## Service Bulletin

SB08-53-01

ENGINE COWLING ALIGNMENT INSPECTION AND MODIFICATION

To provide a more detailed inspection of the engine cowling installation for alignment, fit, and clearance with the fuselage; and for cracks in the firewall. To provide modifications for the cowling shock mount attach brackets and engine baffle seals.

Figure 1. Cowling Alignment Fit and Clearance (Sheet 1)

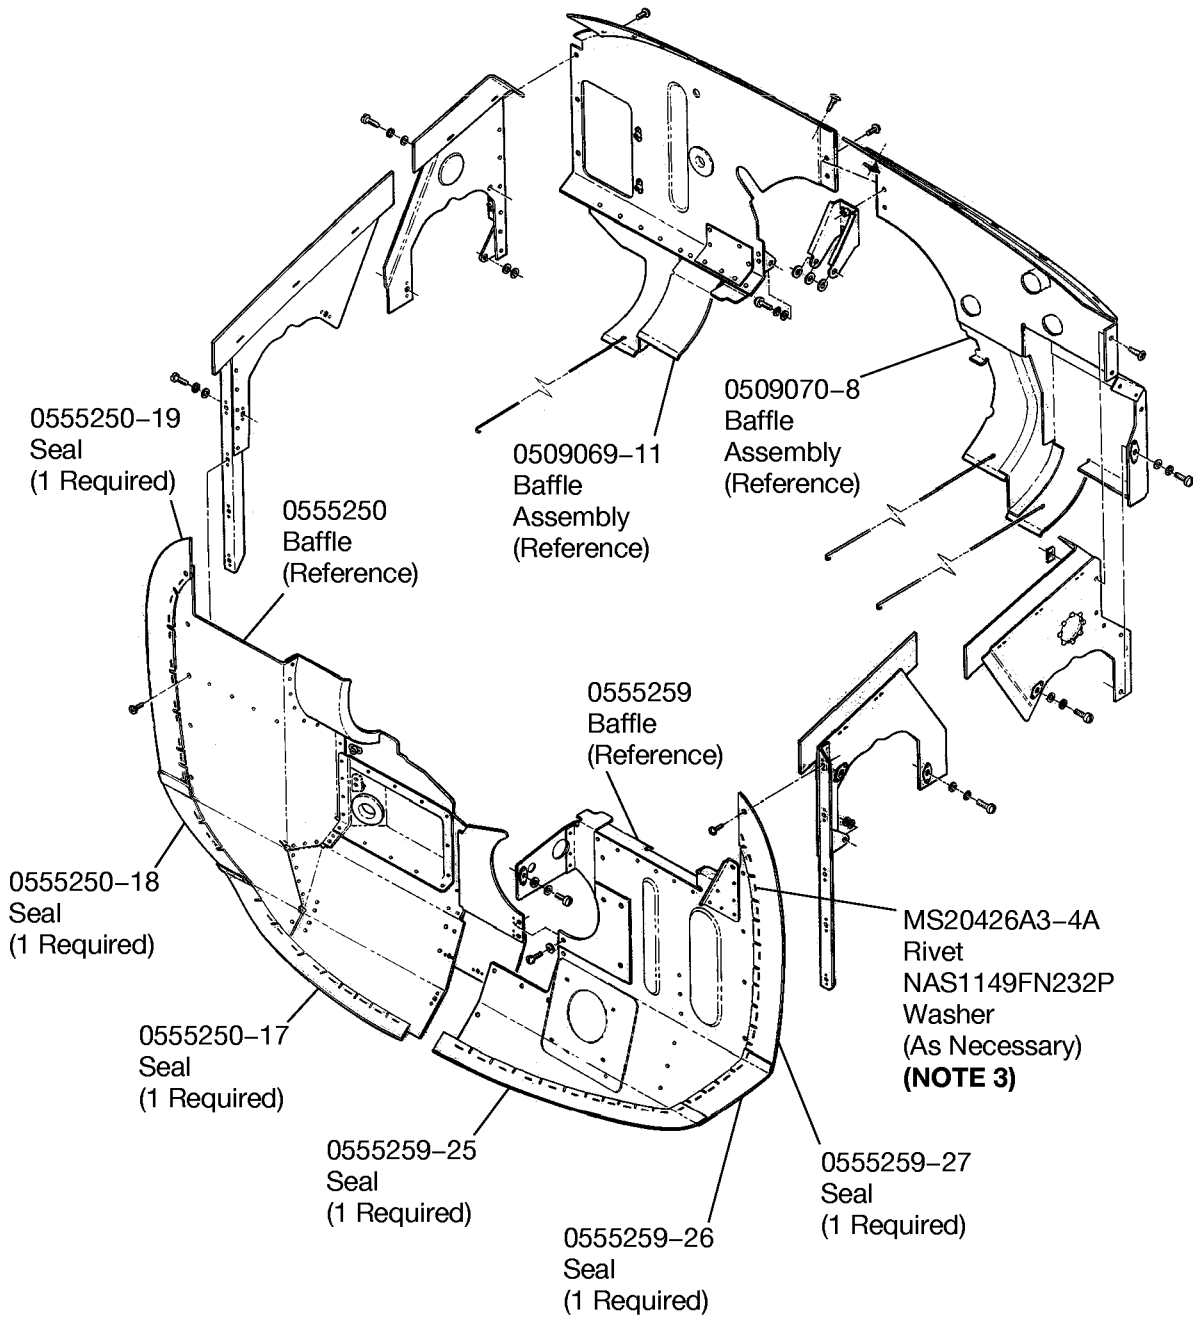
D. (Refer to Figure 1, Detail A and Detail B.) Look for evidence of wear between the upper cowling stiffener and the metal part of the baffles. Record all affected areas.

- (7) Install the upper and lower cowlings and do Steps 21A through 21A(6) again until there is necessary clearance.
- 22. (Refer to Figure 1, Detail A.) Do a visual inspection of the upper engine cowl to look for signs of wear on the forward S2319 Cowl Fasteners, for signs that the forward S2319 Cowl Fasteners are going to pull through or have pulled through the upper engine cowl, and for wear on the forward doubler on the bottom side of the upper engine cowl.

26. (Refer to Figure 1, Detail A.) Examine the aft end of the 0552212-23 and the 0552212-24 Stiffener on the upper right and upper left sides of the lower cowling, and examine the firewall flange and forward fuselage skin for signs that they have worn against the 0552212 Stiffener.

25. Do the steps below in addition to the steps that you have already done to better adjust the fit of the cowling.
- A. (Refer to Figure 1, Detail A and B.) Make necessary clearance adjustments between the 0552170 Upper cowling Stiffeners and the engine baffles.

Figure 1. Cowling Alignment Fit and Clearance (Sheet 2)

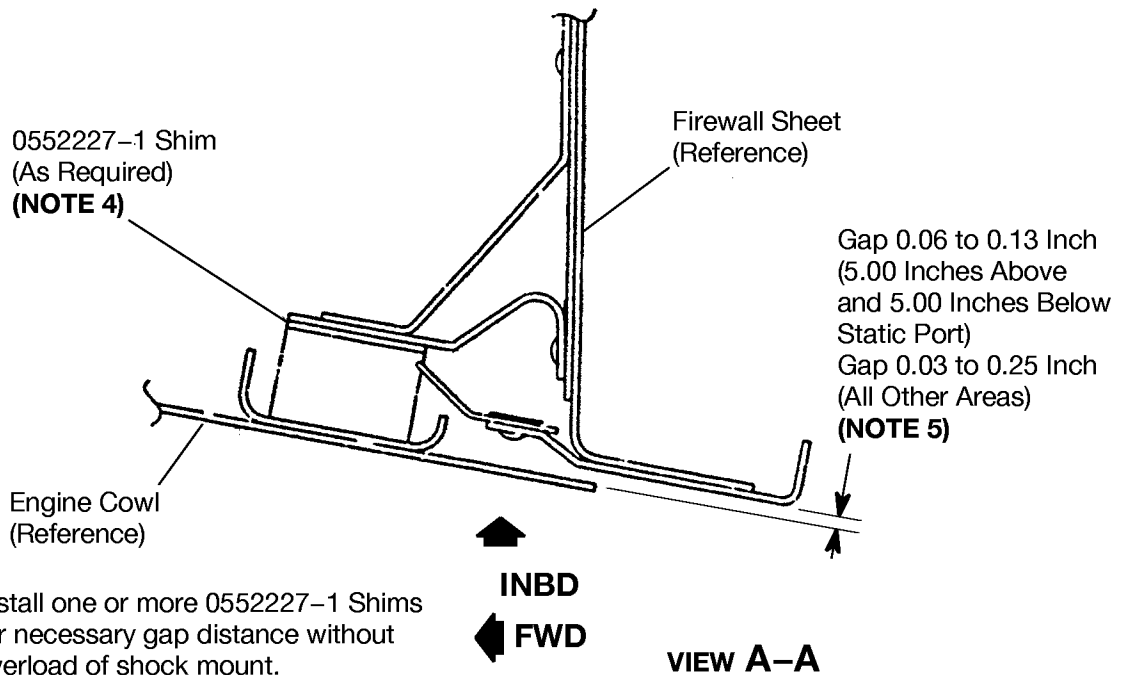
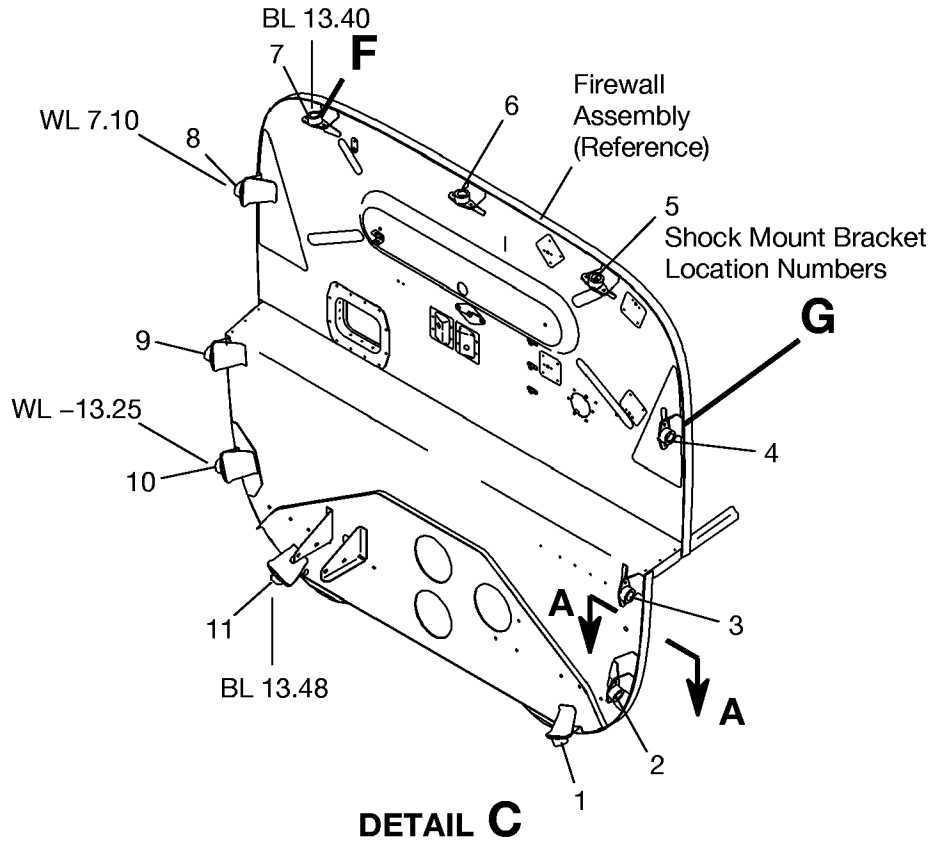
- B. (Refer to Figure 1, Detail B.) Replace the seals on the forward right hand baffle assembly with new seals. (Refer to the Model 172R/172S Illustrated Parts Catalog, Chapter 71, Engine Baffles Installation.)

C. (Refer to Figure 1, Detail B.) Replace the seals on the forward left hand baffle assembly with new seals. (Refer to the Model 172R/172S Illustrated Parts Catalog, Chapter 71, Engine Baffles Installation.)

- (2) (Refer to Figure 1, Detail B.) Install new 0555259-25, 0555259-26, 0555259-27 Seals to the 0555259 Forward Left Hand Baffle Assembly with MS20426A3-4 Rivets and NAS1149FN232P washers.

Figure 1. Cowling Alignment Fit and Clearance (Sheet 3)

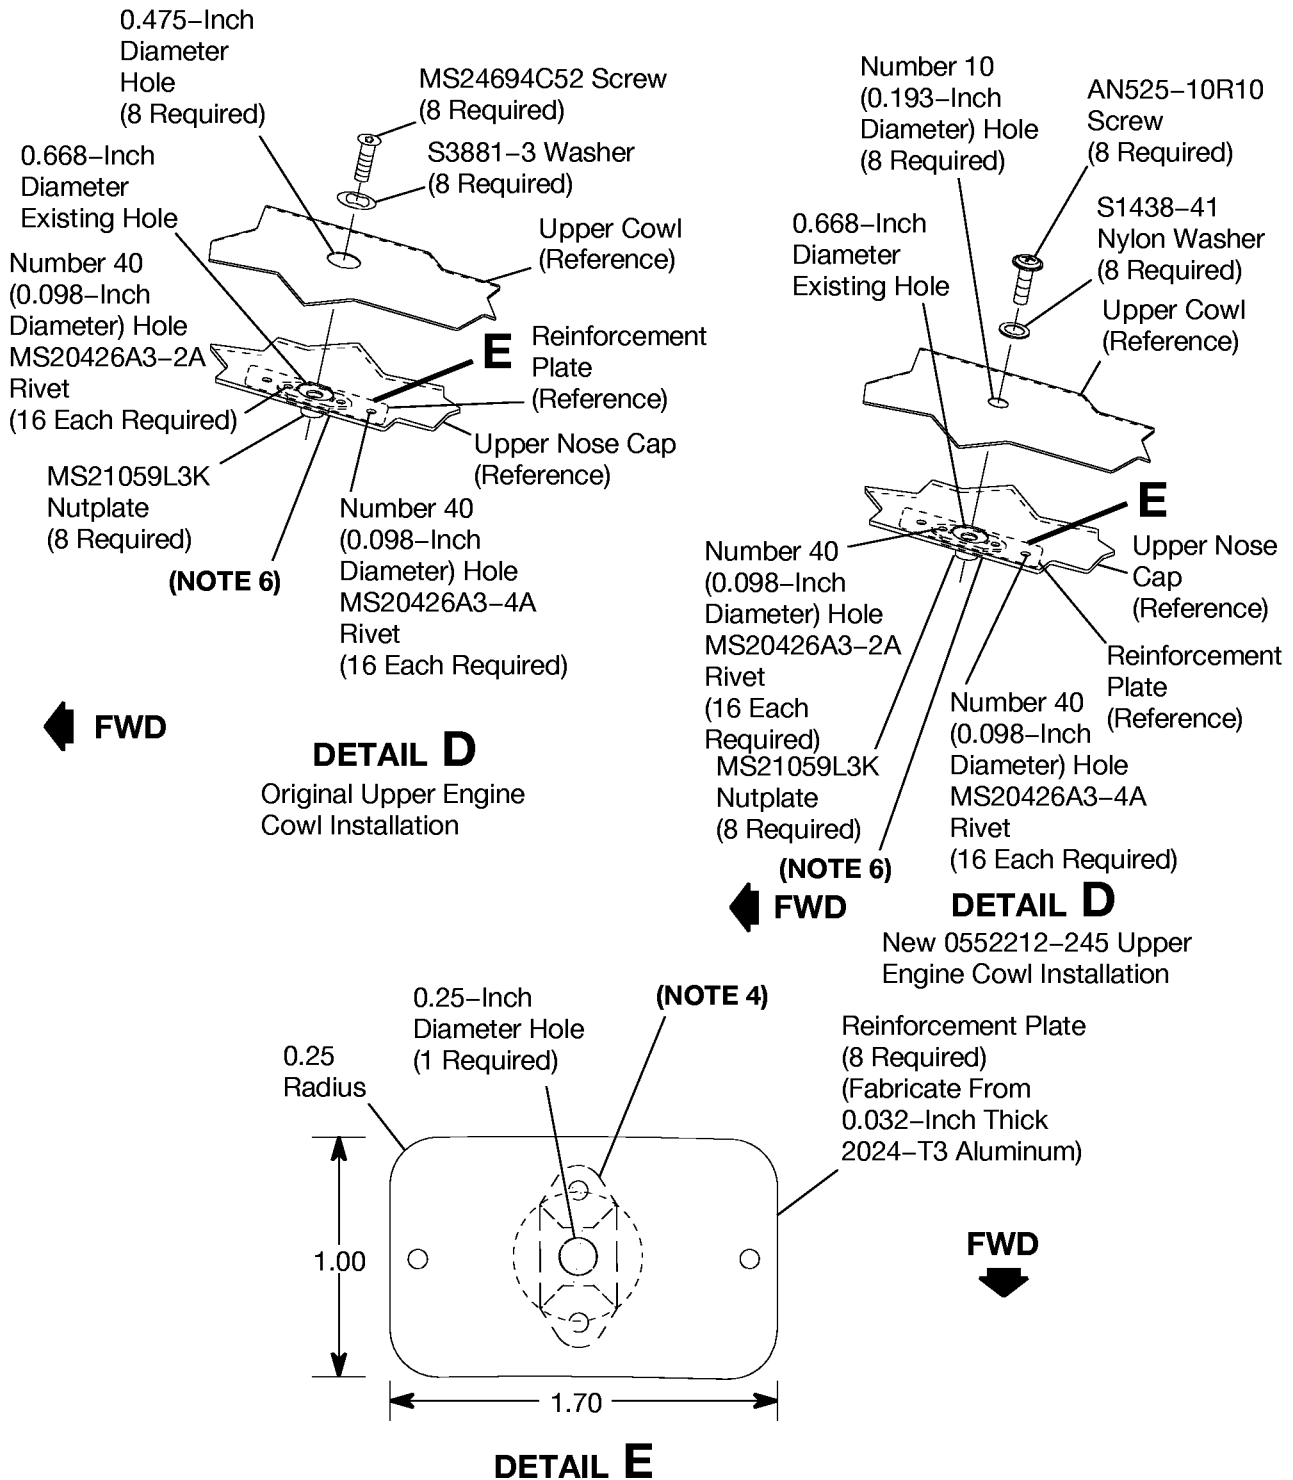
- C. (Refer to Figure 1, Detail C and View A-A.) Measure the gap between the aft edge of the upper and lower cowlings, and the forward fuselage skin.

- (1) Measure the gap between the inner surface of the cowling skin and the exterior surface of the forward fuselage skin adjacent to each S2319 Cowl Fastener.
- (2) (Refer to Figure 1, Detail C.) Give special attention to the right and left cowling corners on the upper cowling between the BL 13.40 and WL 7.10 S2319 Cowl Fastener locations, and on the lower cowling between the BL 13.48 and WL 13.25 S2319 Fastener locations.
- (3) Make a note about each shock mount location if the gap is not within specification.
  - (a) Write the measurements on masking tape and put next to each S2319 Cowl Fastener location as you do the inspection.
  - (b) Write the cowling fit inspection measurements in Table 1, Cowling Fit Dimensions.

**NOTE:** (Refer to Figure 1, Detail C.) Use the firewall bracket position location numbers shown and stamp the number of each shock mount respectively on the adjustment plate.

- H. (Refer to Figure 1, Detail C.) Make sure to mark the location of each 0591009-2 Shock Mount Adjustment Plate.
- I. (Refer to Figure 1, Detail C.) Remove material from the adjustable plates as necessary to give clearance from the engine cowling, engine mount truss, and the firewall. Make sure that the cowling channel does not touch the edges of the adjustment plate at locations 1, 2, 5, 7, 10, and 11.

- A. (Refer to Figure 1, Detail C and View A-A.) Do a measurement of the gap between the aft edge of the upper and lower cowlings, and the forward fuselage skin.

- (1) Measure the gap between the inner surface of the cowling skin and the exterior surface of the forward fuselage skin adjacent to each S2319 Cowl Fastener.
- (2) (Refer to Figure 1, Detail C.) Give special attention to the right and left cowling corners on the upper cowling between BL 13.40 and WL 7.10 1/4 turn fastener locations, and on the lower cowling between BL 13.48 and WL 13.25 1/4 turn fastener locations.
- (3) Do a visual inspection for necessary clearance of all shock mounts, brackets, and shock mount adjustment plates.
- (4) Identify each location where the gap is not within specification.
- (5) Remove the upper and lower cowlings.
- (6) Remove the shock mount plates that are out of tolerance and install 0552227-1 Shims as necessary to get the necessary gap.

**NOTE 4:** Install one or more 0552227-1 Shims for necessary gap distance without overload of shock mount.

**NOTE 5:** Measure gap between nearest cowling fuselage skin or fastener.

Figure 1. Cowling Alignment Fit and Clearance (Sheet 4)

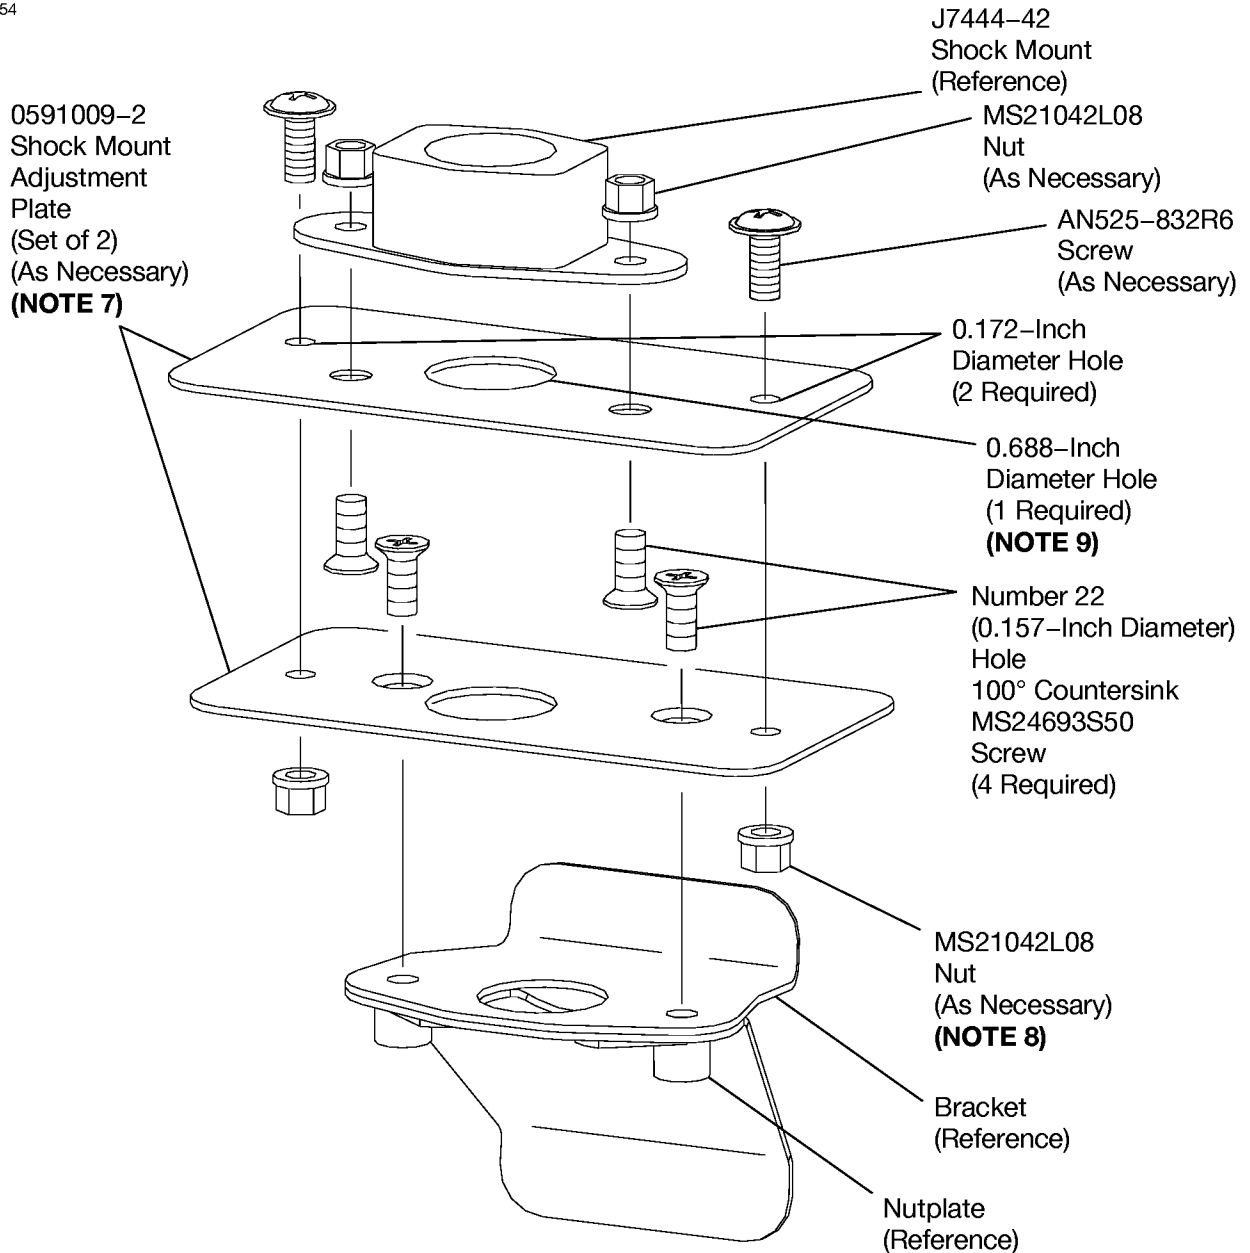
- (9) (Refer to Figure 1, Detail D.) Remove the upper cowl and drill a 0.475-inch hole where the Number 30 size hole was drilled in the step above. Deburr and Alodine the hole.

- (21) (Refer to Figure 1, Detail D.) Install the eight new MS21059L3K Nutplates to the new reinforcement plates that are attached to the upper nose-cap with the 16 MS20426AD3-2 Rivets.

- H. (Refer to Figure 1, Detail D.) Install the eight new MS21059L3K Nutplates to the eight new reinforcement plates with the 16 MS20426AD3-2 Rivets.

- I. Install the eight reinforcement plates on the bottom of the upper nose-cap with 16 MS20426A3-4 Rivets.
  - J. (Refer to Figure 1, Detail D.) Install the upper engine cowl with the S2319 Cowl Fasteners on the aft, left, and right sides of the engine cowl and eight new MS24694C52 Screws and S3881-3 Washers.

**NOTE 6:** Turn the MS21059L3K nutplate as necessary to align the nutplate and to give an edge distance of no less than two fastener diameters.

Figure 1. Cowling Alignment Fit and Clearance (Sheet 5)

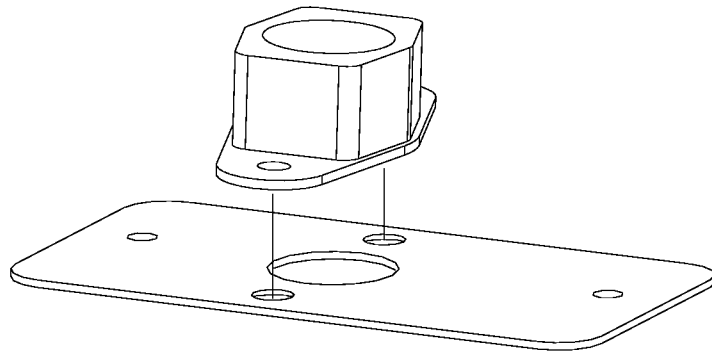
16. (Refer to Figure 1, Detail F.) Install the shock mounts.

- G. (Refer to Figure 1, Detail F.) With the two center holes aligned from both 0591009-2 Shock Mount Adjustment Plates, drill two 0.172 inch holes as shown. Make sure to center the holes as necessary to maintain a minimum edge distance of 0.344 inch.

**NOTE 9:** Center hole under the shock mount through both 0591009-2 Shock Mount Adjustment Plates.

**DETAIL G**  
Mount Locations  
1, 4, 8, and 11  
**(NOTE 10)**

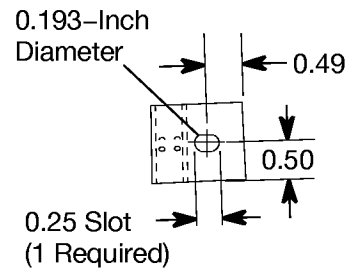
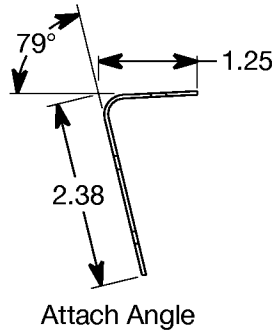
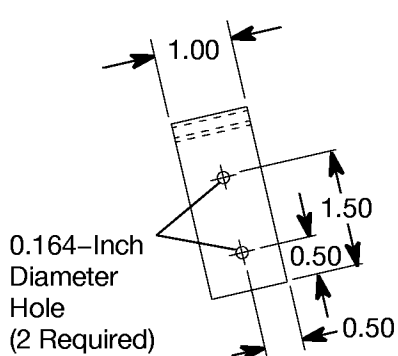
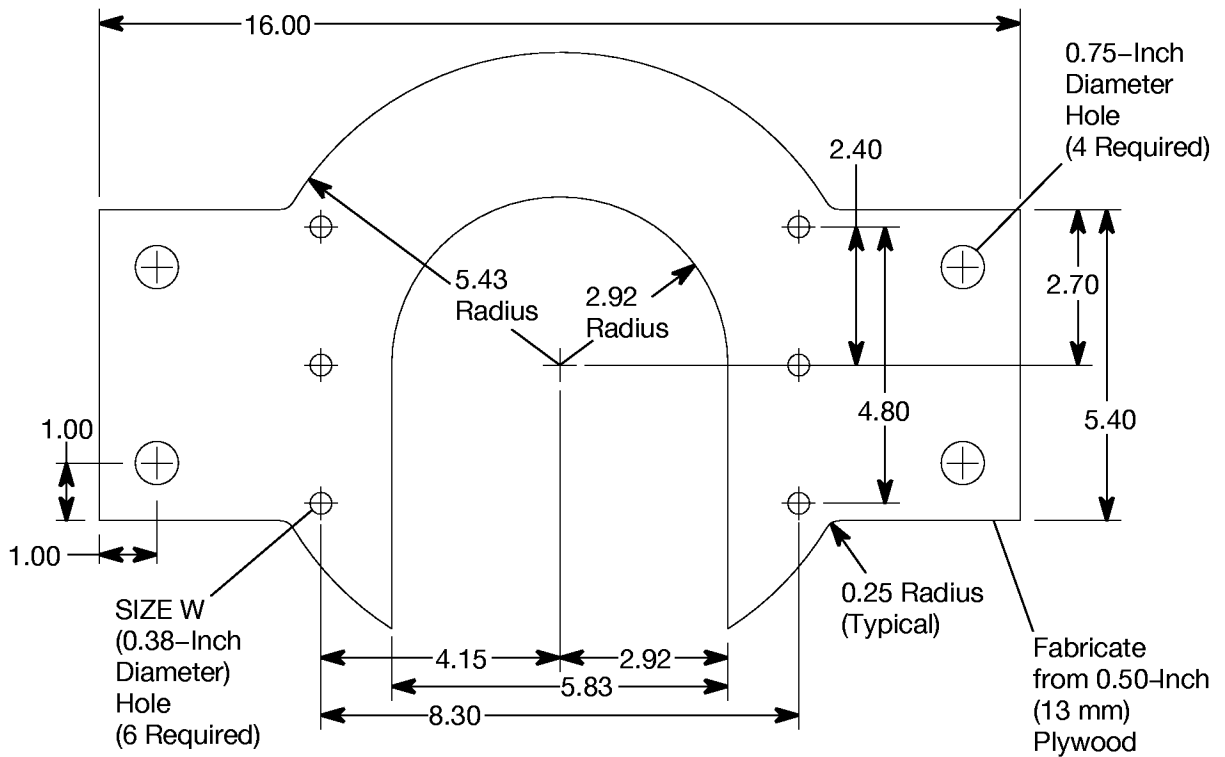
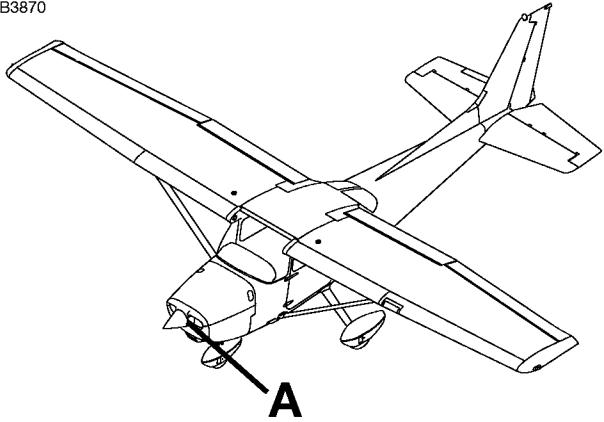
**NOTE:** (Refer to Figure 1, Detail F and Detail G.) Each shock mount bracket may need either one or two 0591009-2 Shock Mount Adjustment Plates to be installed to get good alignment between the cowling fastener and the shock mount as shown in the illustration.

**NOTE:** (Refer to Figure 1, Detail G.) 0591009-2 Shock Mount Adjustment Plates 1, 4, 8, and 11 located near the engine truss, may have the shock mounts mounted horizontally for clearance from the engine truss.

**NOTE 10:** It is permissible to install the shock mount adjustable plates at locations 1, 4, 8, and 11 in the same orientation as shown in Detail G. Remove material from the plates as necessary to get 0.05-inch clearance between the adjustable plates, engine mounts, and firewall.

Figure 2. Nose Cap Alignment Template (Sheet 1)

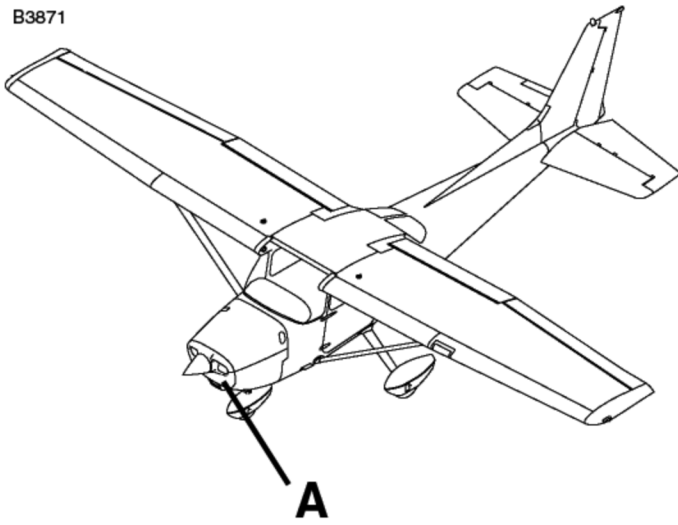
- A. (Refer to Figure 2, Detail A and Figure 3, Detail C.) Make a nose cap alignment fixture.

- B. (Refer to Figure 2, Detail A.) Fabricate two attach angles from 2024-T3 Aluminum.

**NOTE:** (Refer to Figure 2, Detail A.) The six small holes in the fixture are positioned for clearance of the rivet butts that protrude through the spinner aft bulkhead so the fixture will fit flat against the bulkhead.
